**RE: Applications PR-2023-008710 & SI-2025-00082
U-Haul Site Plan
8200 Jefferson St NE, Albuquerque, NM**

Thank you for your time reviewing the U-Haul Site Plan application for the proposed development at 8200 Jefferson St NE. We received your comments dated February 11, 2025 and have addressed your comments. Below we have copied all your review comments and then provided written responses explain how each item was addressed.

SHEET CONTENTS:
ALTERNATIVE
PLANTING PLAN

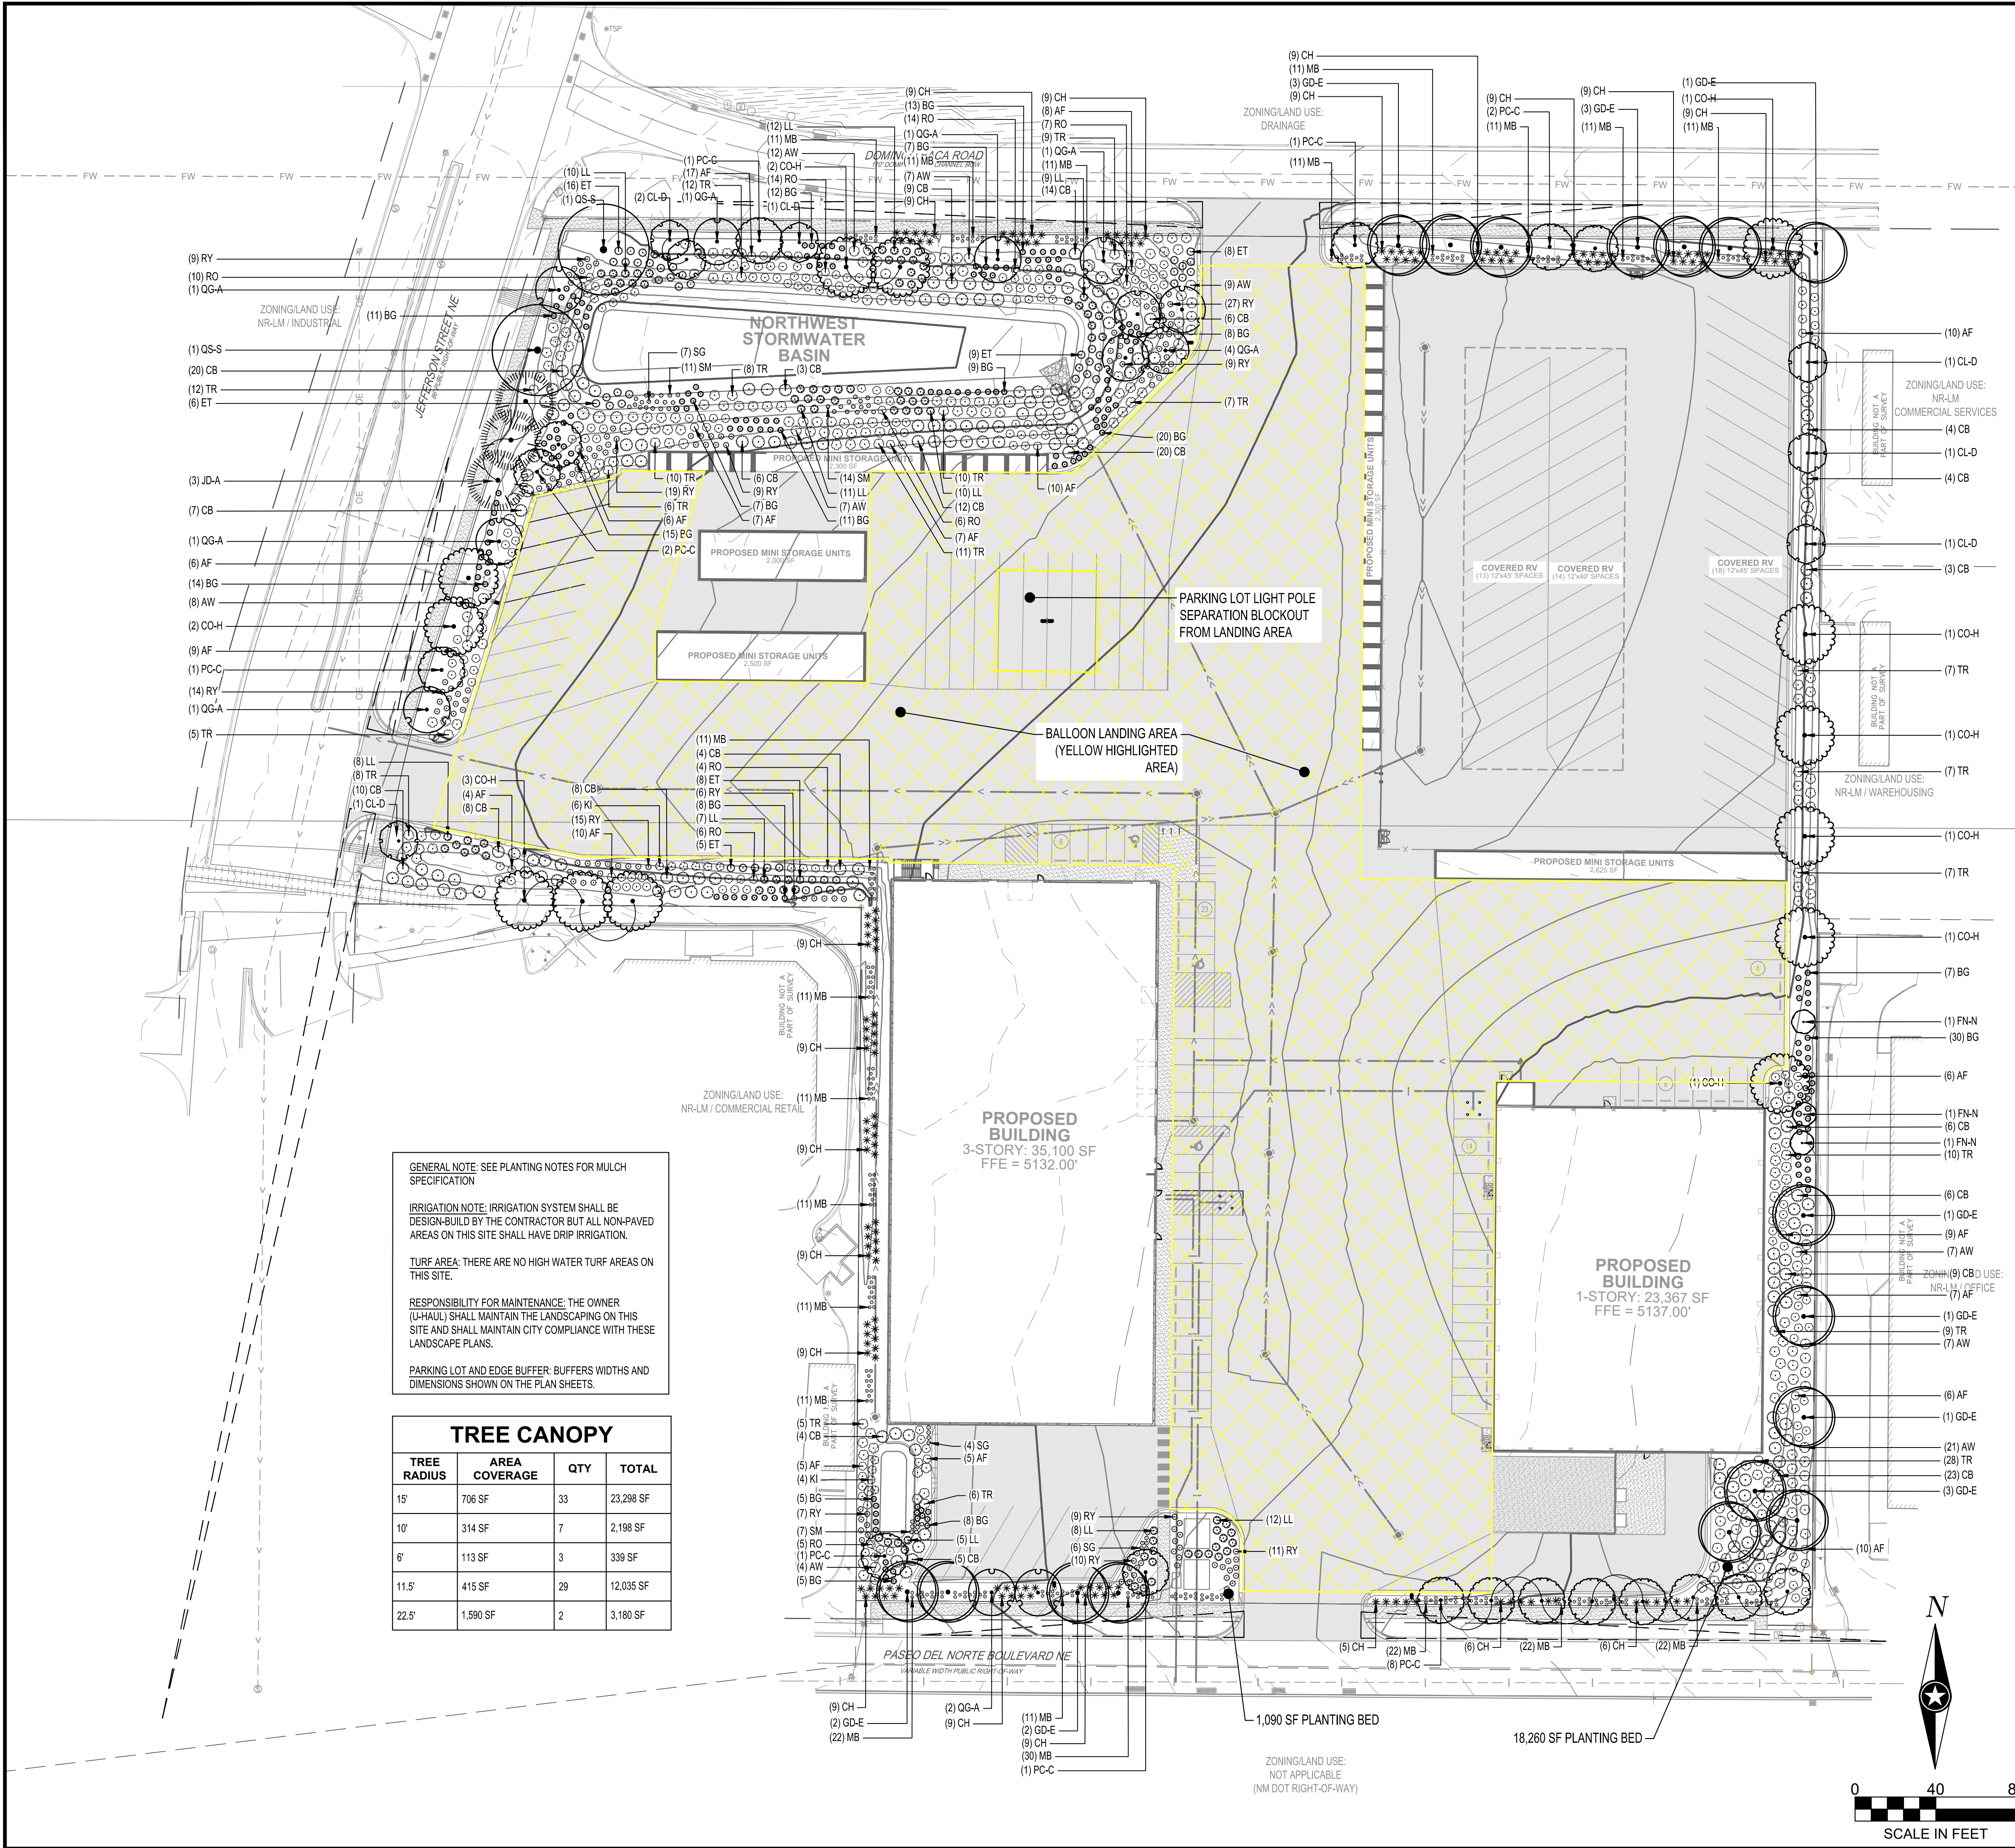
1. A The last memo requested: a separate application to include information on how landscaping was altered to accommodate the balloon landing area.
2. Please show dimensions of the landing area for balloons on the site (Once dimensions of the landing area are confirmed, we will request feedback from the Balloon Landing Task Force on the proposed landing area to confirm if they are okay with it).

3. It appears the Alternative Landscaping Plan submitted is the same landscape plan in the February 12th submittal for the Site Plan Administrative DFT for PR-2023-008710 / SI-2025-00082.

- a. Regarding the required parking lot landscaping, since you are seeking to reduce or eliminate these specific requirements due to the balloon landing area, with the Alternative Landscaping Plan this is permitted provided the required parking lot trees are moved to other areas of the site. In other words, tree reduction is not allowed. This needs to be shown in your calculations.

- b. Please address the following Park and Recreations comments below:
- c. Per IDO 5-6(C)(5)(c) The use of gravel or crusher fines as ground cover is limited to a maximum of 75 percent of any landscaped area, or 50 percent in DT-UC-MS areas.
- d. Calculations must be provided on the landscape plan data section. You can certainly provide street trees in the area shown along Paseo del Norte Blvd (marked up in gold for your review):
- e. Also, -Per IDO 5-6(C)(5)(e) Organic mulch is required as ground cover under trees, within a 5-footradius around the tree trunk, but not directly against the trunk. In these areas, weed barrier fabric is prohibited. (See figure below.) Tree planting detail must be provided and show 5' radius organic mulch around tree trunk.

ISG Response: These items have been updated.

DECIDUOUS TREE PLANTING
NTS

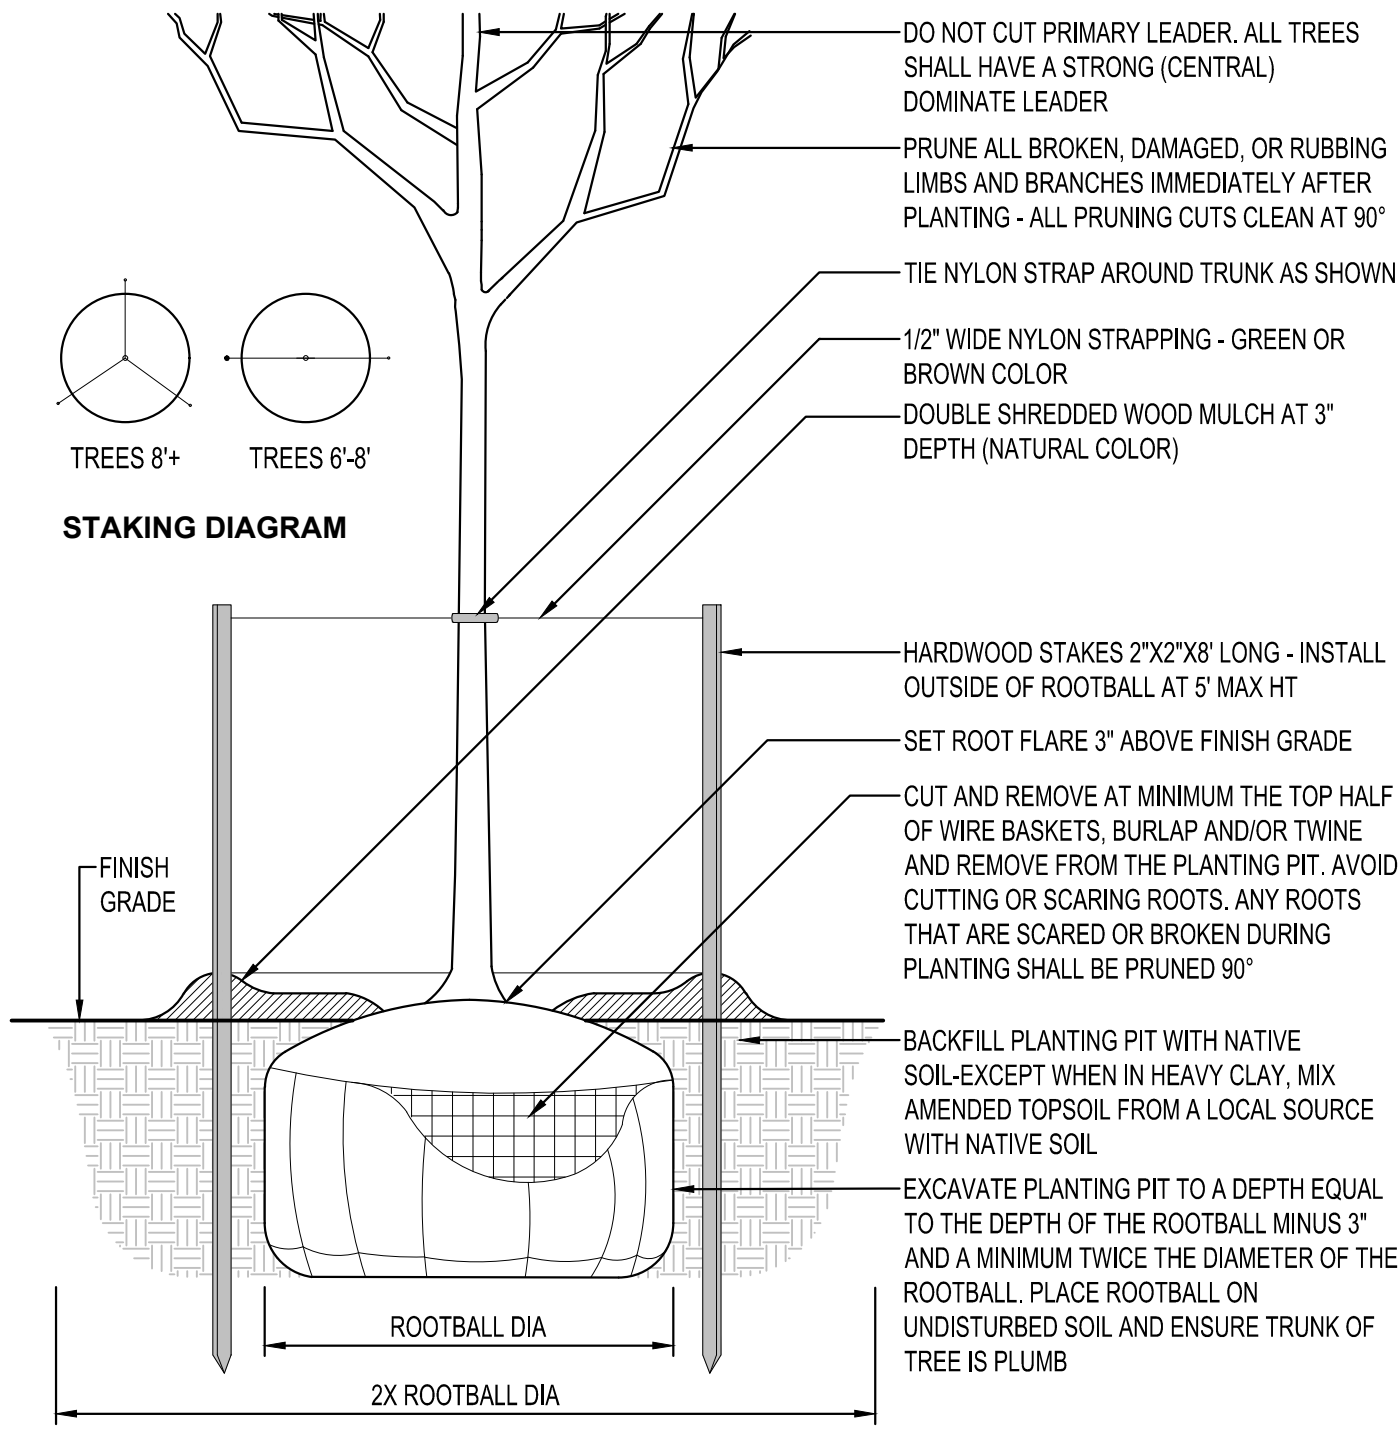
6. Tree planting detail must show 5' radius organic mulch around tree trunk.

ISG Response: This has been updated.
